Access Compliance Report

Public Rights-of-Way

(Curb Ramps)

Intersection ID: 30284	Main Street: RAVANNA_DR	Cross Street: SMITHTON_LN	Location: W
ADA ID: 08DEAE9DD605	Ramp Type: PerpDiag	Initial Pass/Fail: Fail	Overall Compliance: No
Severity Score: 47.5			
Codes/Mitigation Info/Possible Solution		Field Measurements/Component Compliance

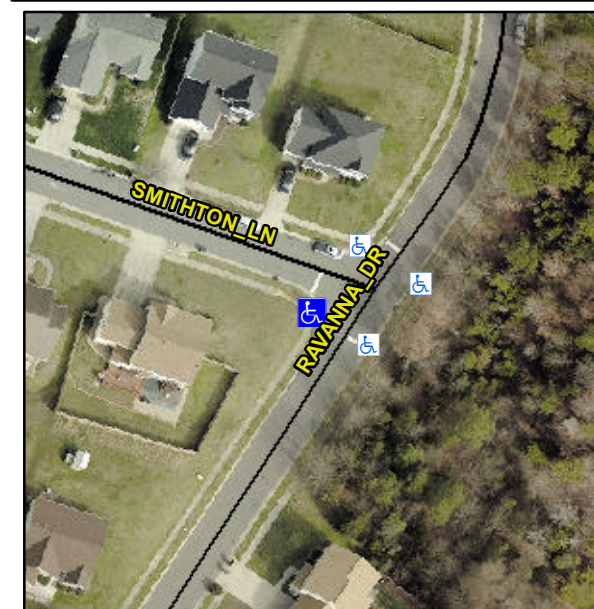
Not Found, R304.5.1, R304.5.3

Compliance	Description	Data	Compliance	Description	Data
N/A	Ramp Length (in)	44.0	Yes	Ramp Slope (%)	5.7
No	Ramp Width (in)	30.0	No	Ramp XSlope (%)	5.7
N/A	Flare Type LT	N/A	N/A	Flare Type RT	N/A
N/A	Flare Slope LT (%)	N/A	N/A	Flare Slope RT (%)	N/A
N/A	Flare Traversable LT?	N/A	N/A	Flare Traversable RT?	N/A
N/A	Landing Length (in)	N/A	N/A	DWS Provided?	N/A
N/A	Landing Width (in)	N/A	N/A	DWS Contrast?	N/A
N/A	Landing Slope (%)	N/A	N/A	DWS Length (in)	N/A
N/A	Landing X Slope (%)	N/A	N/A	DWS Full Width?	N/A
N/A	Landing Curb? (Y/N)	N/A	N/A	DWS Offset (in)	N/A
N/A	Shared Landing?	N/A			
N/A	Gutter Ponding?	N/A	N/A	Gutter Slope (%)	N/A
N/A	Gutter Lip Ht (in)	N/A	N/A	Gutter X Slope (%)	N/A
N/A	Painted X Walk1?	No	N/A	Painted X Walk2?	No
	X Walk 1 Direction	To S		X Walk 2 Direction	To N
N/A	X Walk 1 Width (in)	N/A	N/A	X Walk 2 Width (in)	N/A
	X Walk 1 Slope (%)	1.4		X Walk 2 Slope (%)	7.1
	X Walk 1 X Slope (%)	9.1		X Walk 2 X Slope (%)	1.4

Remove & Replace Curb Ramp With Two New Directional Ramps or Equivalent.
